**PLANNING COMMISSION MINUTES
EXCERPT JANUARY 23, 2008
(DISCUSSION OF PROPOSED REZONING)**

CITY OF NOVI
 Regular Meeting
 Zoning Map Amendment 18.673 and PRO SP07-59
 Basilian Fathers Excerpt
Wednesday, January 23, 2008 | 7 PM
 Council Chambers | Novi Civic Center | 45175 W. Ten Mile

**PLANNING MEMO REVIEW
OF REVISED CONCEPT PLAN**

**PLANNING REVIEW
FOR REZONING 18.673 AND PLANNED
REZONING OVERLAY**

REDUCED CONCEPT PLAN

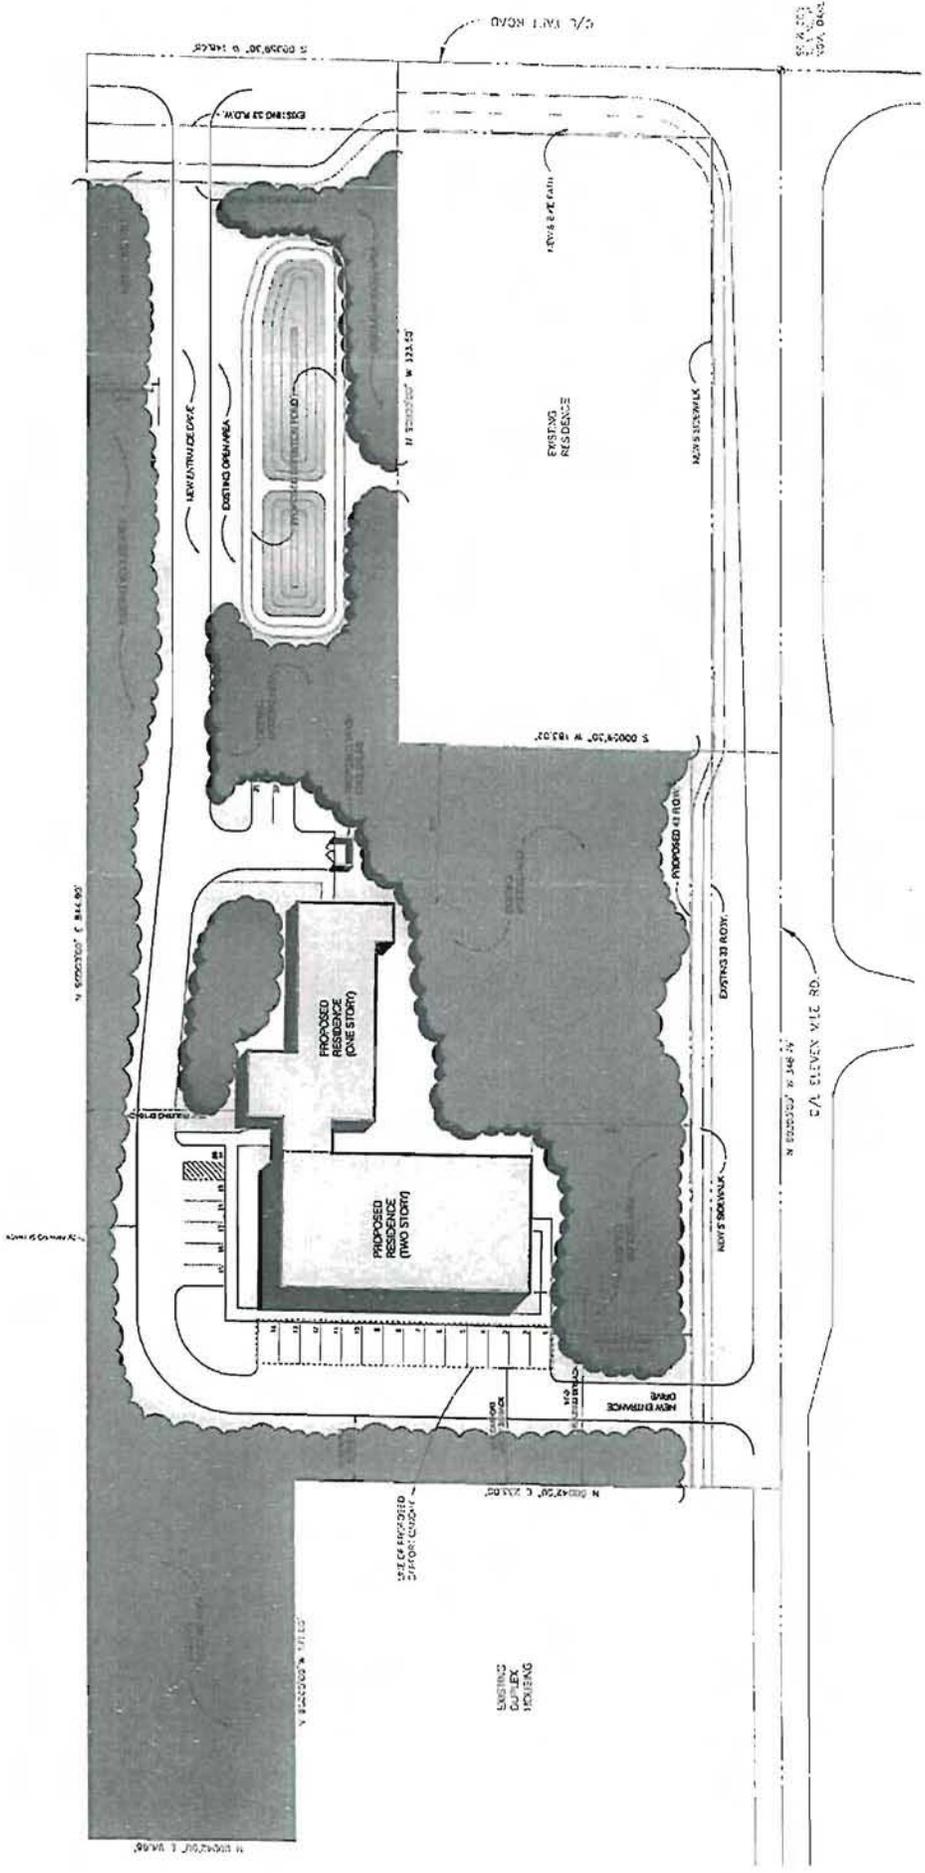
- Front Yard: The applicant is proposing 66 feet of setback. This appears to be deficient. **The Community Development Department finds that the City Council should act on this ordinance deviation in the PRO Agreement.**
- Rear Yard: The applicant is proposing 35 feet of setback for the rear yard parking. The Community Development Department finds no need for deviation in this situation as this meets the requirements of the ordinance.
- Side Yards: The applicant is proposing 20 feet of setback for the interior side yard and 300+ feet of setback for the exterior side yard. The Community Development Department finds no need for deviation in this situation as this meets the requirements of the ordinance.

- Front Yard: The applicant is proposing 66 feet of setback for the rear yard. This appears to be deficient. **The Community Development Department finds that the City Council should act on this ordinance deviation in the PRO Agreement.**
- Rear Yard: The applicant is proposing 81 feet of setback. The Community Development Department finds no need for deviation in this situation as this meets the requirements of the ordinance.
- Side Yards: The applicant is proposing 55 feet of setback for the interior side yard. This appears to be deficient. **The Community Development Department finds that the City Council should act on this ordinance deviation in the PRO Agreement.**
- The proposed carport is setback appropriately from the building.

The Barrier Free Code indicates that one barrier free van accessible space should be provided for any parking area having one to twenty-five spaces. The applicant has included one van accessible barrier free space on the revised concept plan.

A five foot sidewalk is required along the Eleven Mile Road frontage and an eight foot sidewalk is required along the Taft Road frontage. The applicant has included the required sidewalks along Eleven Mile Road and Taft Road.
